SWRCB - DWR  
'19 FEB 26 AM 11:04Pacific Power |  
Rocky Mountain Power  
825 NE Multnomah, Suite 1800  
Portland, Oregon 97232

February 26, 2019

Re: PacifiCorp Comments on the Draft Environmental Impact Report for the Lower Klamath Project License Surrender

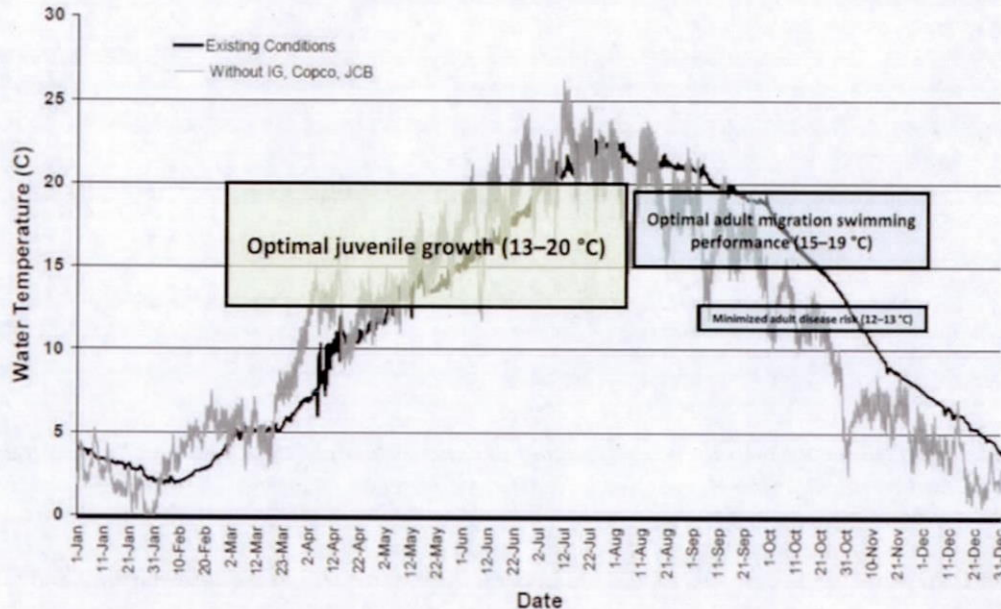
According to Bartholomew and Foott (2010 as cited in the DEIR), the 59°F (15°C) water temperature criterion that is referenced in the DEIR applies when the infectious dose of *C. shasta* is low. However, DEIR fails to present the complete finding of Bartholomew and Foott (2010, page 38) that water temperature is not a strong predictor of survival when infectious dose is high. Specifically, Bartholomew and Foott (2010) show substantial effects on salmonids at temperatures ranging from about 55°F to almost 70°F (13°C to 21°C). Simulated water temperature information presented in the DEIR indicates that water temperatures would reach 13°C in early April for the Proposed Project compared to early May for existing conditions (Figure 10). While the DEIR claims that warmer water temperatures in spring under the Proposed Project would result in earlier fry emergence for mainstem Chinook spawners, this would not be the case for tributary populations. Juvenile migration timing for tributary populations would remain unchanged and the majority of these fish would enter a warmer Klamath River under the Proposed Project, with all of its implications for disease.

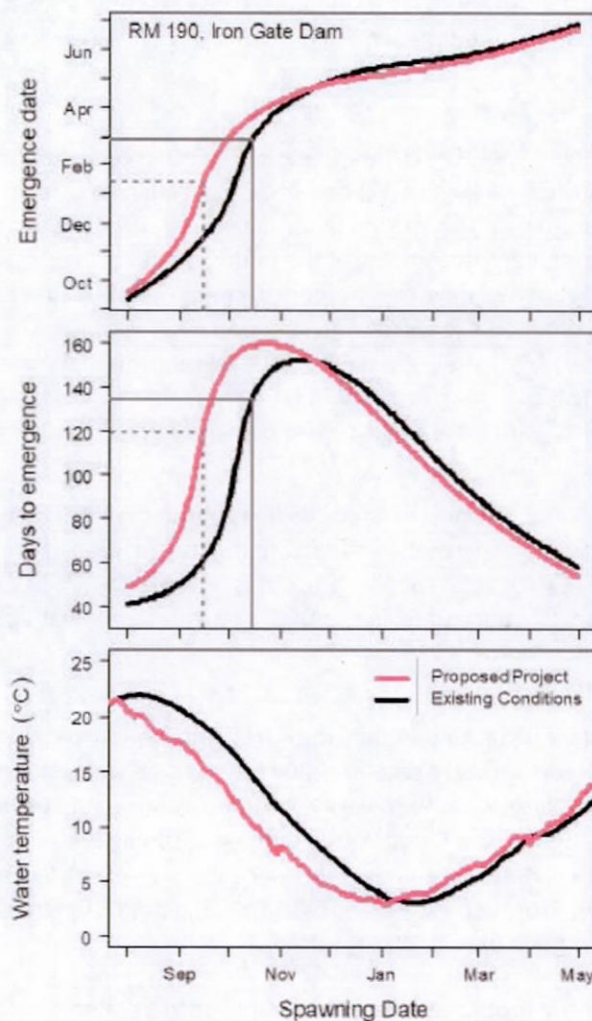
While text presented throughout the DEIR claims an earlier fry emergence timing for fall-run Chinook under the Proposed Project, the data (Figure 11) do not support such an assertion. In fact, the data indicate emergence timing is later for fish spawning on similar dates for the Proposed Project compared to existing conditions. For example, a dotted line in the middle panel of Figure 11 shows that under the Proposed Project there are about 120 days to emergence, compared to 60 days for existing conditions for fish spawning mid-September. This results in fry emergence dates of January (Proposed Project) and November (existing conditions) (Figure 11, top panel). This relationship (i.e., later emergence date for Proposed Project) holds for fish spawning until about late November, when emergence date becomes similar for the two alternatives, with emergence timing being marginally earlier for the Proposed Project.

What is unclear in the DEIR, is the meaning of the solid lines in the days to emergence and emergence date panels (Figure 11 middle and top panels). No explanation is provided in the DEIR text as to what the lines denote. Perry et al. (2011), the reference to which this figure is linked, has temperature data but nothing on emergence timing. It is unclear from the DEIR how this figure was actually derived or if Perry et al. (2011) is even the correct source.
